# CITY OF PORTLAND BUILDING PERMIT

Job ID: 2011-10-2475-ALTR

has permission to Rebuild Second Level/ add Third Floor Addition (with Partial Interior Renovations to the Third Floor), provided that the person or persons, firm or corporation accepting this permit shall comply with all of the provisions of the Statutes of Maine and of the Ordinances of the City of Portland regulating the construction, maintenance and use of the buildings and structures, and of the application on file in the department.

**Jonathan Rioux - Re: 47-79 Lafayette St**

13 SECTIONS: PROPOSED STAIRS - TYP.  
SCALE: 1/2" = 1'-0"

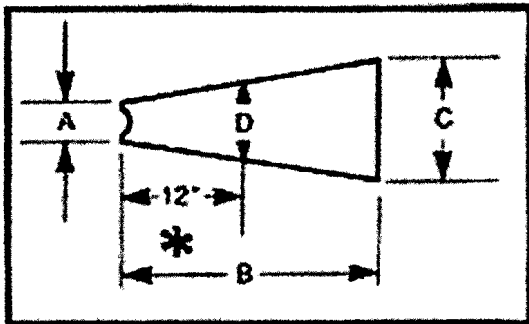
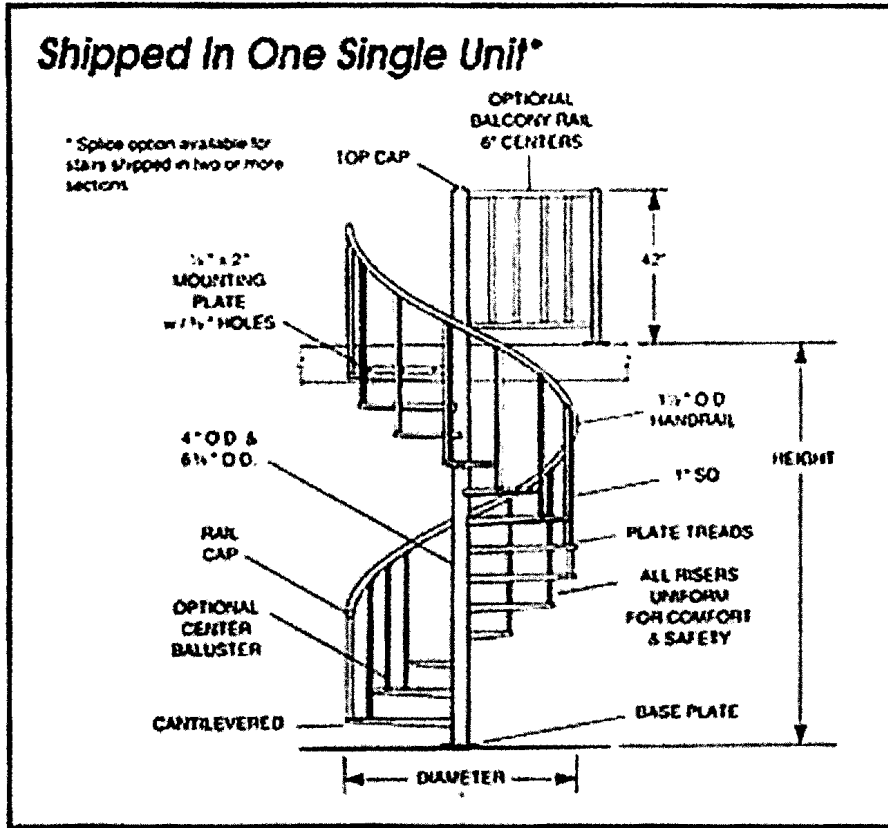
I received your stair detail; the handrail must comply with MUBEC. Attached is the commentary section. JGR.

1 PLOT PLAN - PROPOSED  
SCALE: 1"=10'-0"  
NOTE:  
-INFORMATION FOR THIS SURVEY WAS OBTAINED FROM THE CITY OF PORTLAND TAX RECORDS, ADDITIONALLY IT WAS ALTERED BASED ON A FIELD SURVEY OF THE PROPERTY

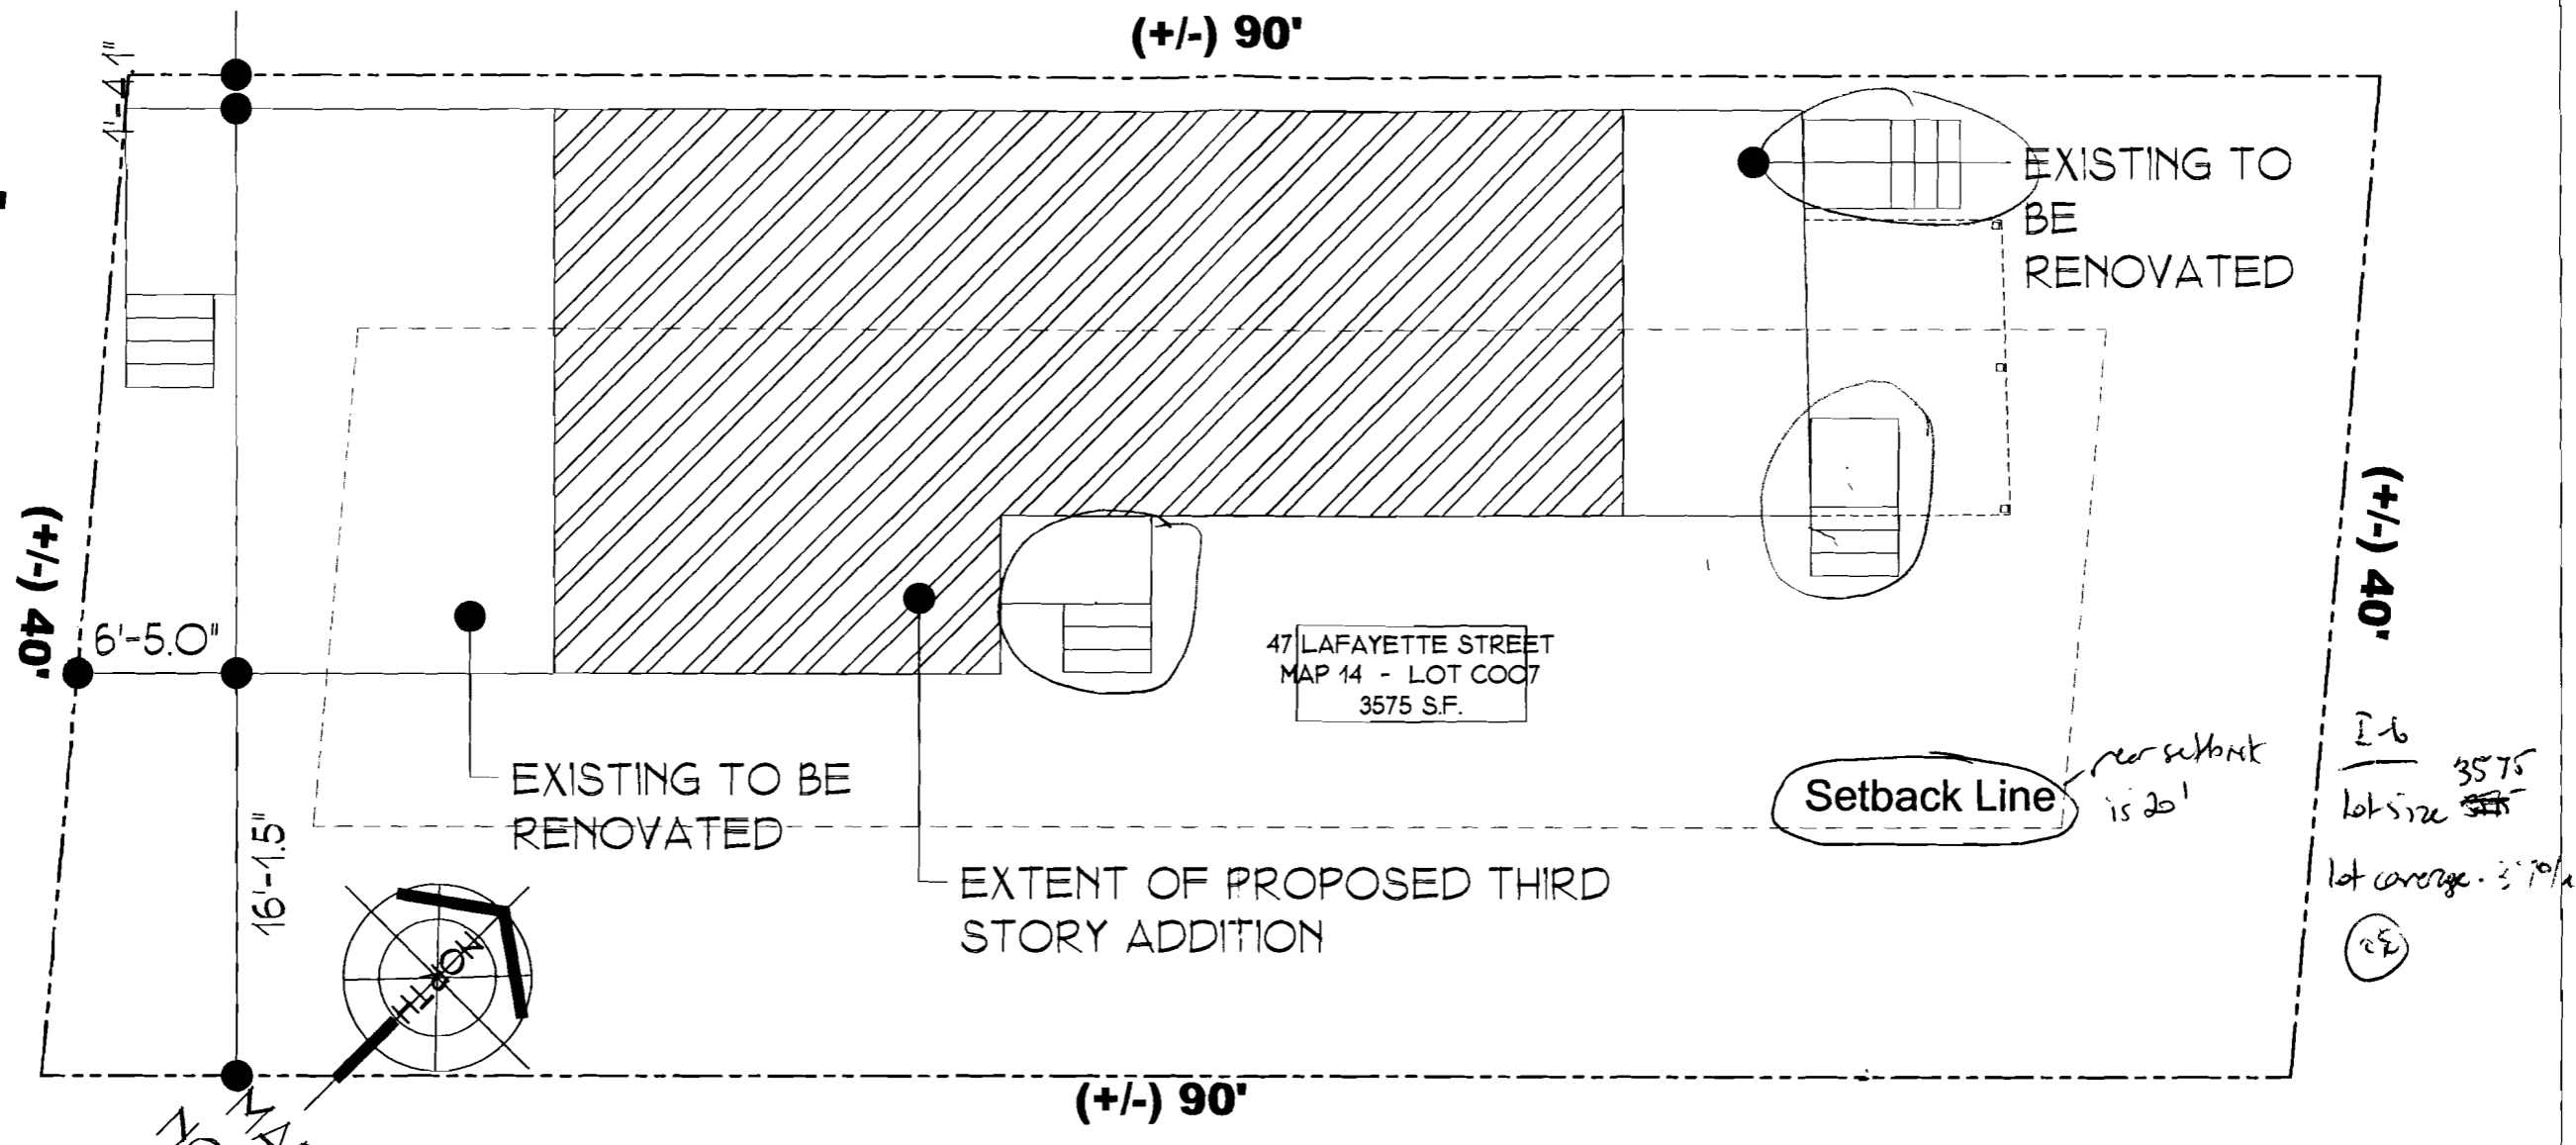
Can you review section R302, see attachment? I took a look at your plot plan, the addition section is > 3 feet.

This would affect window openings and provide protection to the underside of the exterior sheathing.

How far is the adjacent properties? JAR.

Which addition? We only went up. There is no part of the building that is being expanded beyond the original foot-print.

The closest inhabited building is the building to the north, which is probably 15+ feet away. There is a garage - which appears to be used for storage off of the northeast corner of the building. But again, we're not expanding anything outwards towards any of these buildings...
